ARCHITECT'S SUPPLEMENTAL INSTRUCTIONS

PROJECT: Residence at Heritage West

Andover, KS

One (1)

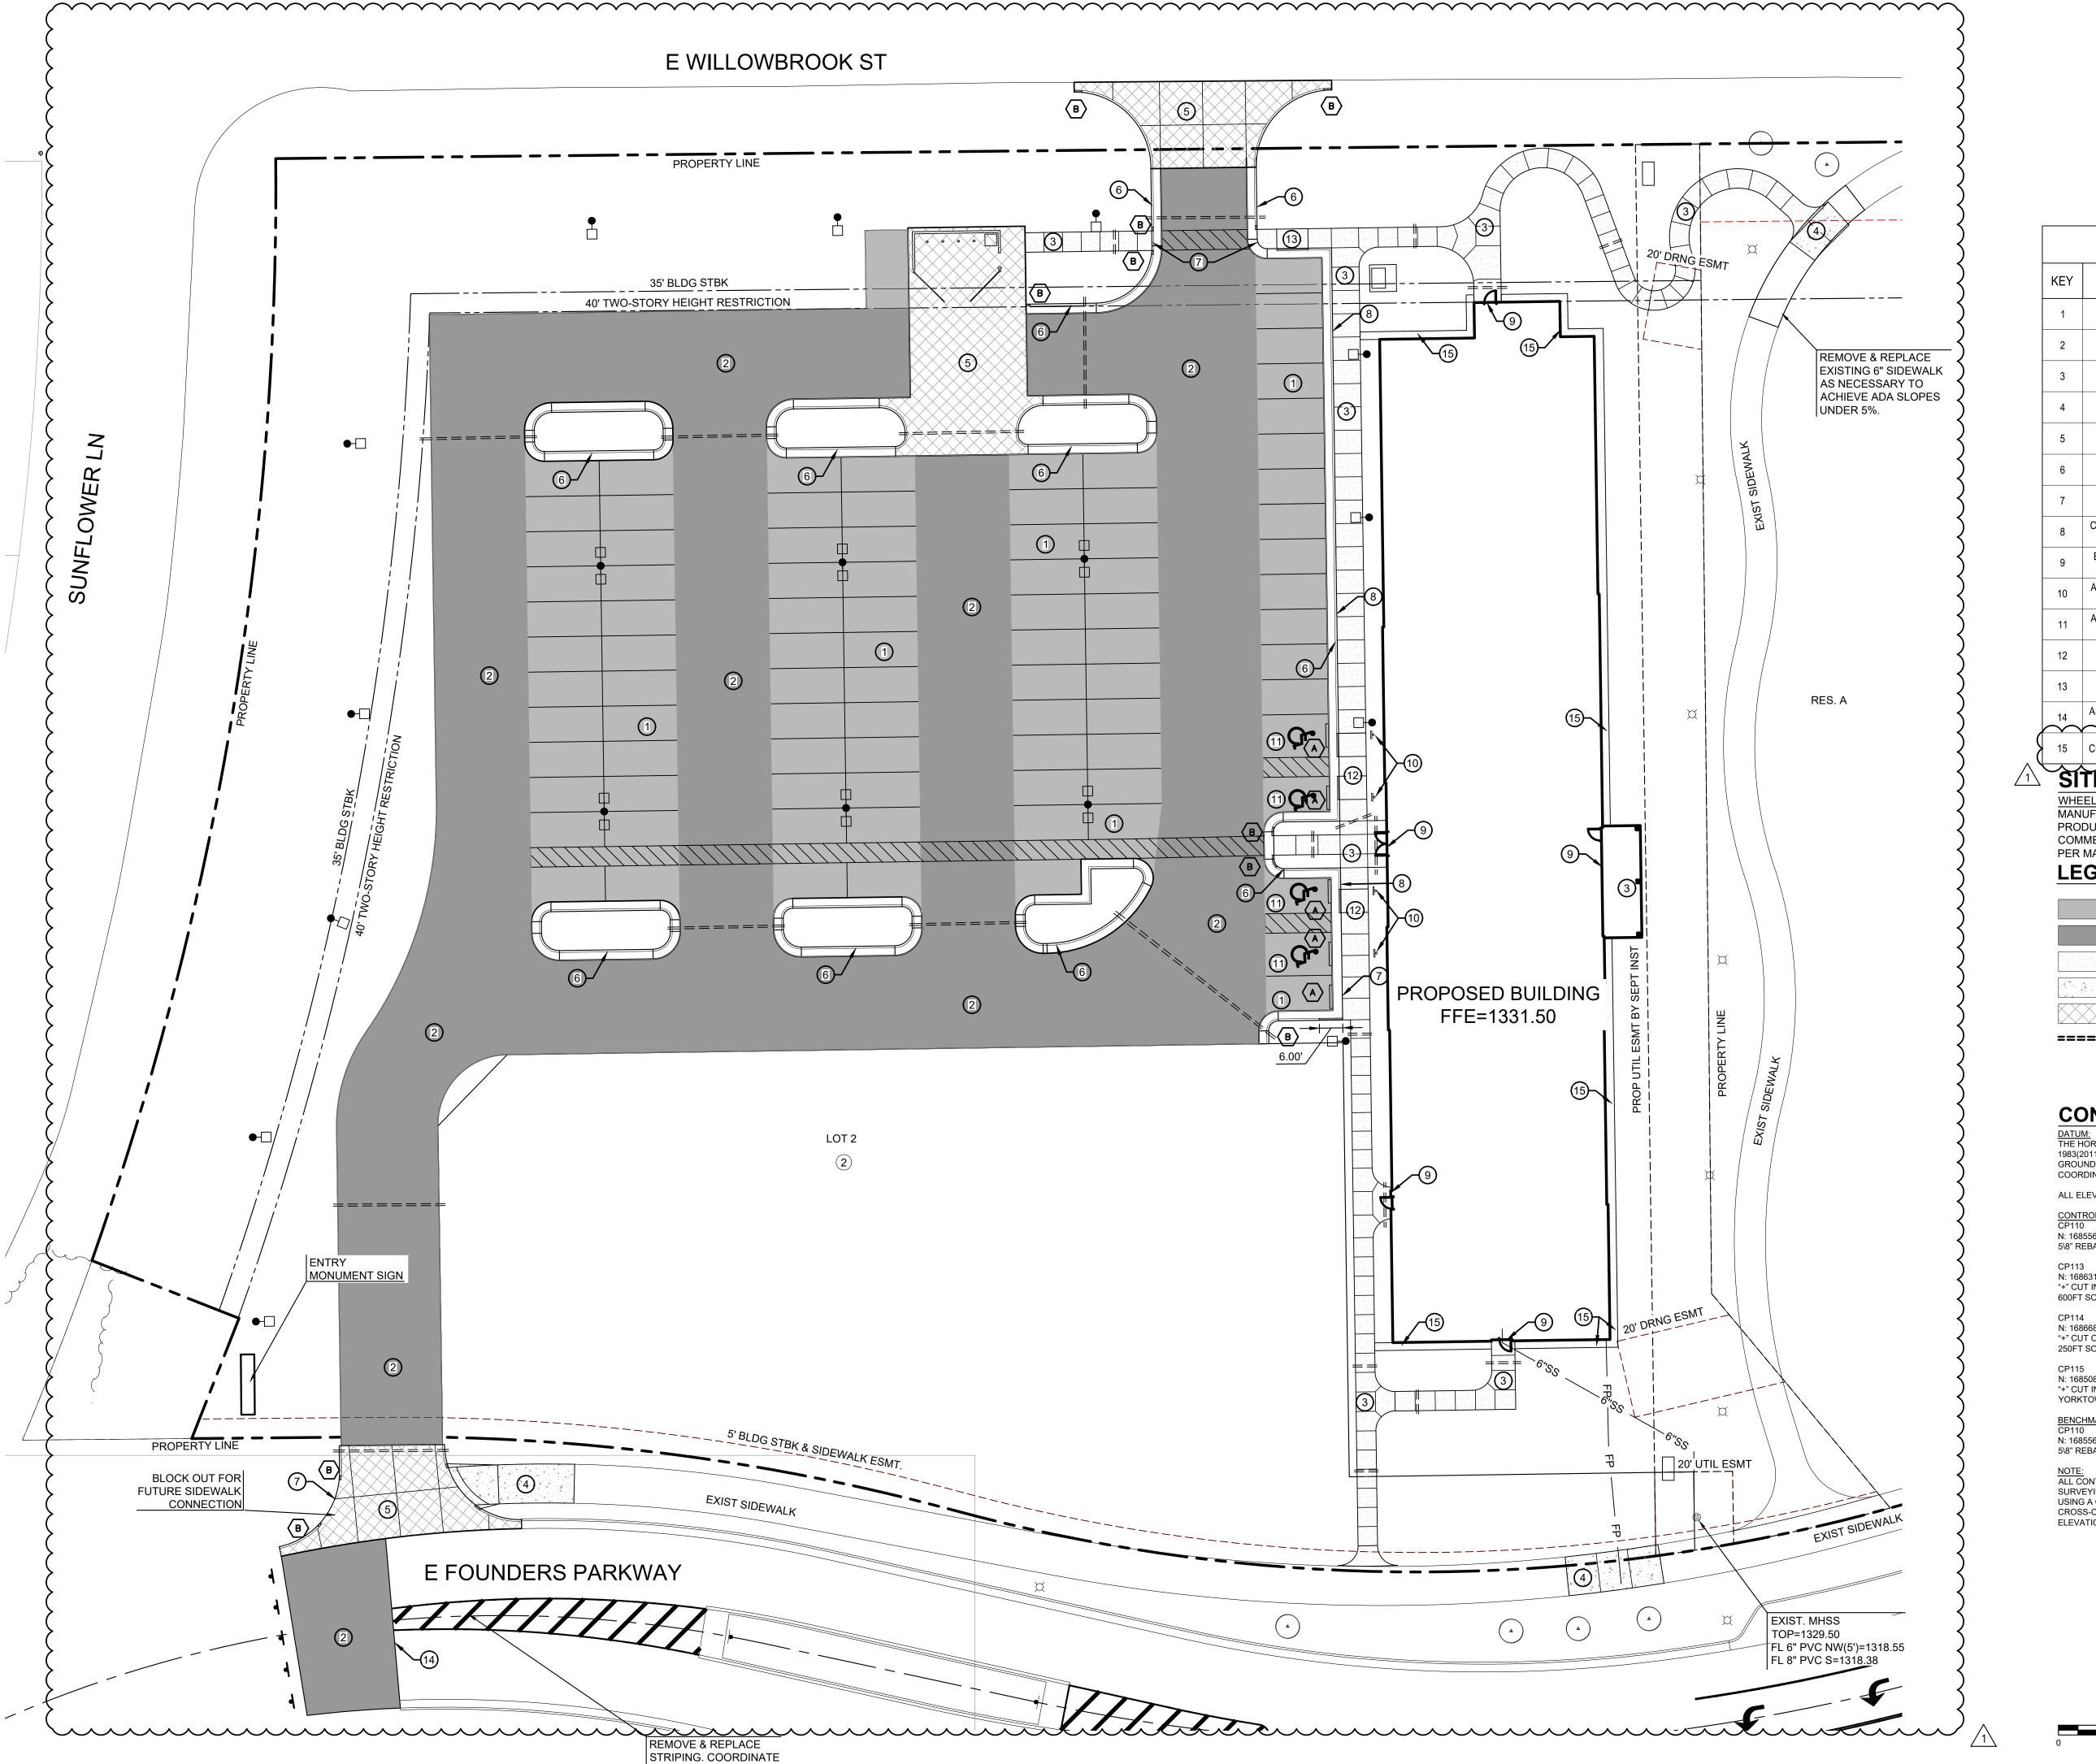
C2.01 Dimension Control Plan – Modified parking lot layout to account for a wider (26' wide) entry aisle for fire trucks and meet IFC requirements for aerial apparatus access roads.

C2.53

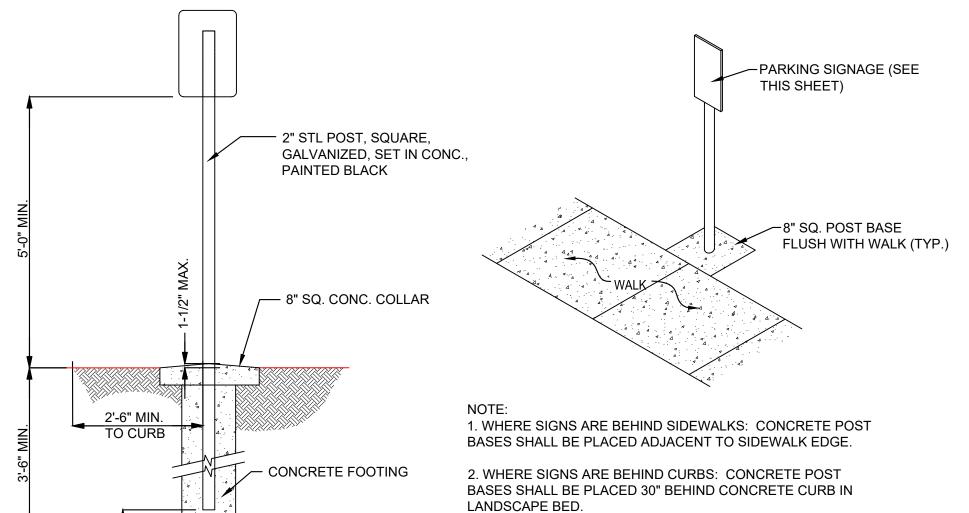
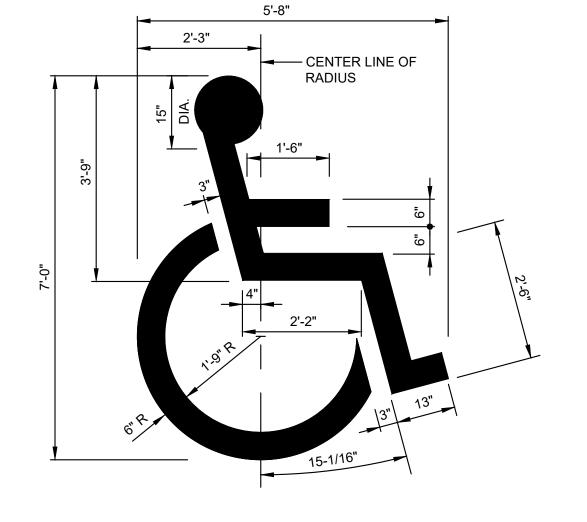
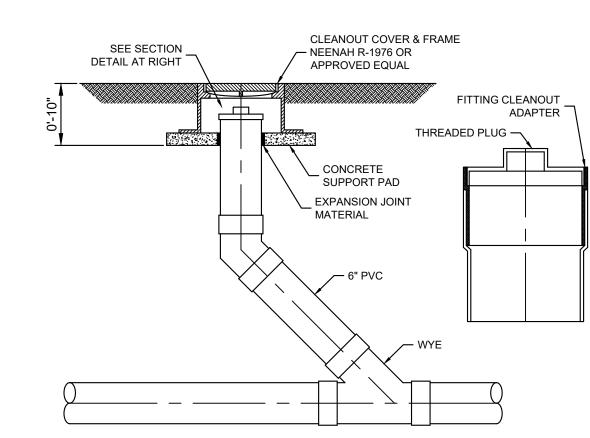
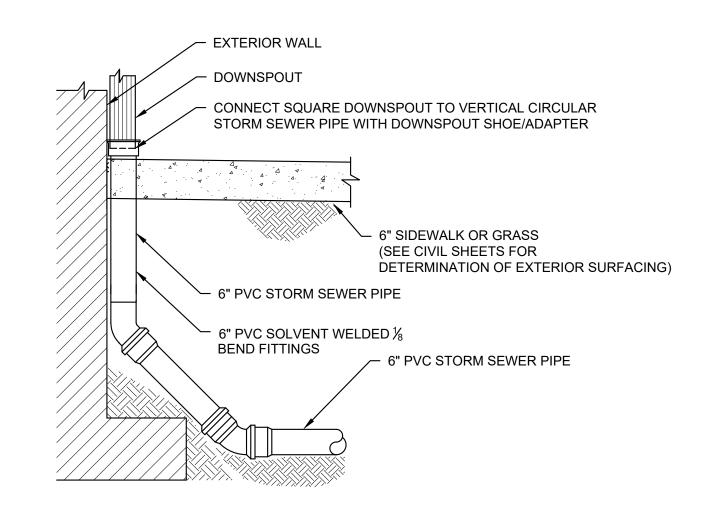
C2.53 Paving Details - Added concrete mow strip detail.

C3.01

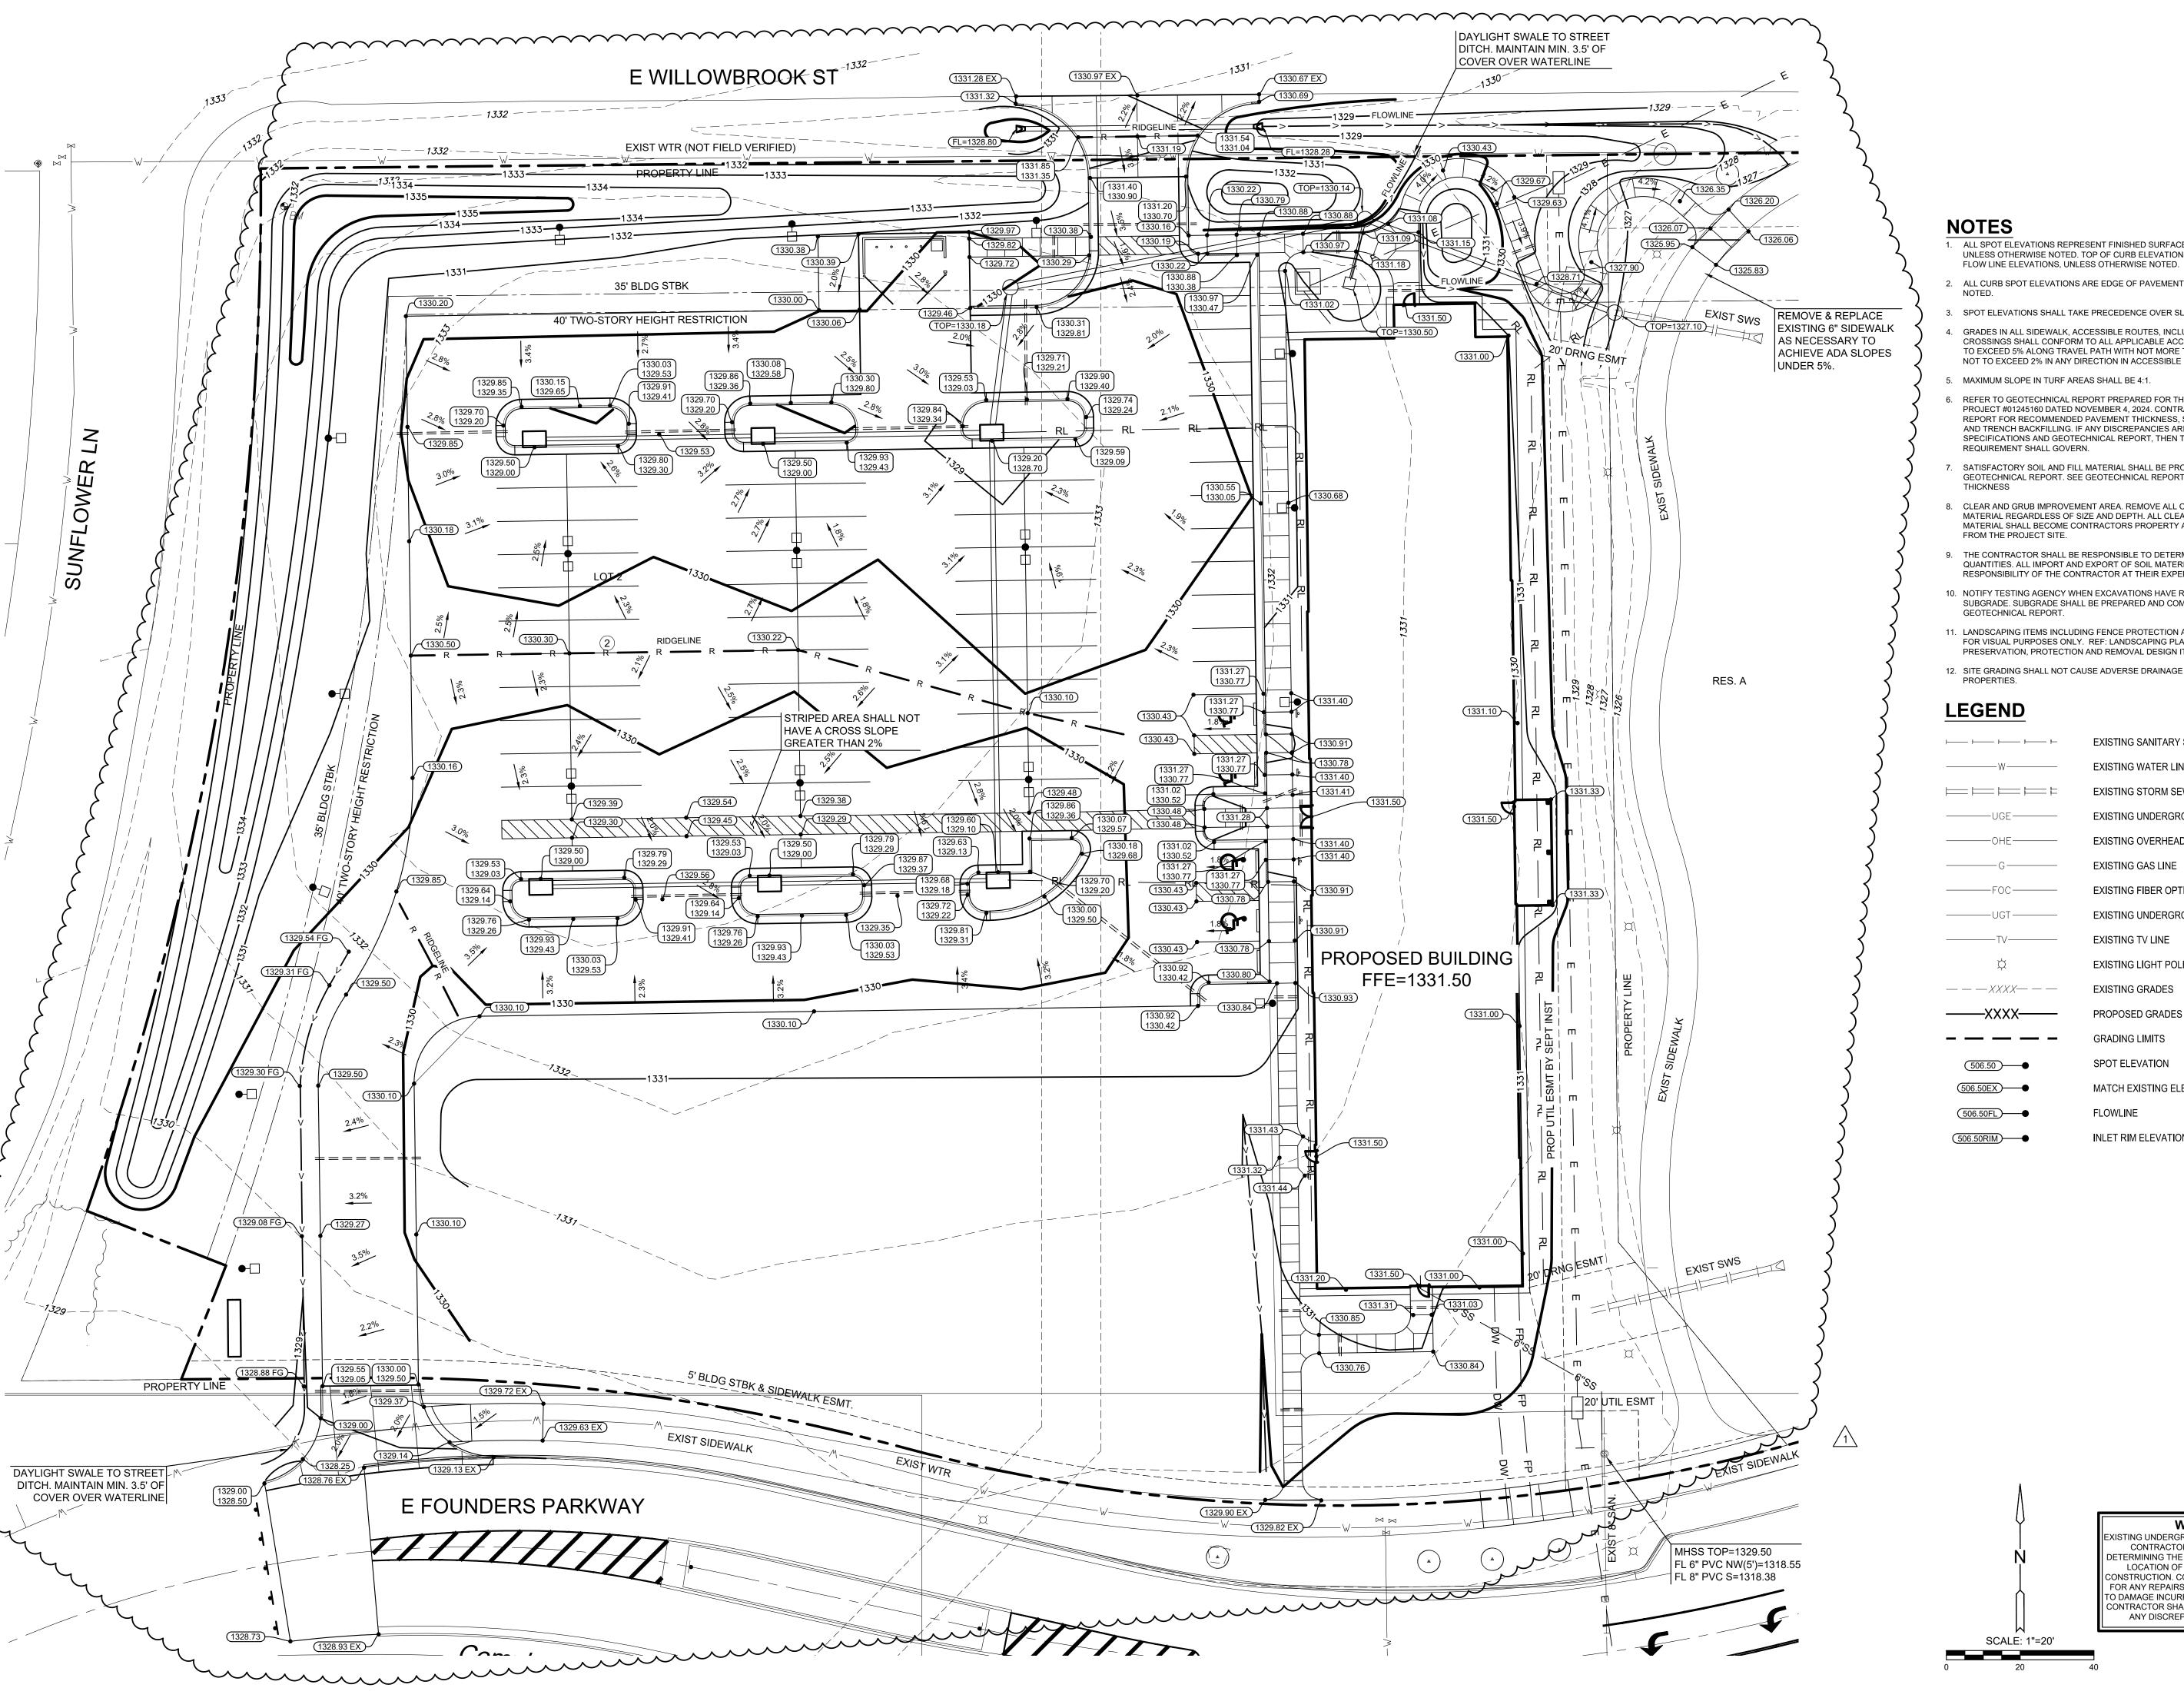
C3.01 Grading Plan - Modified grading design and spot elevations to account for modified site layout.
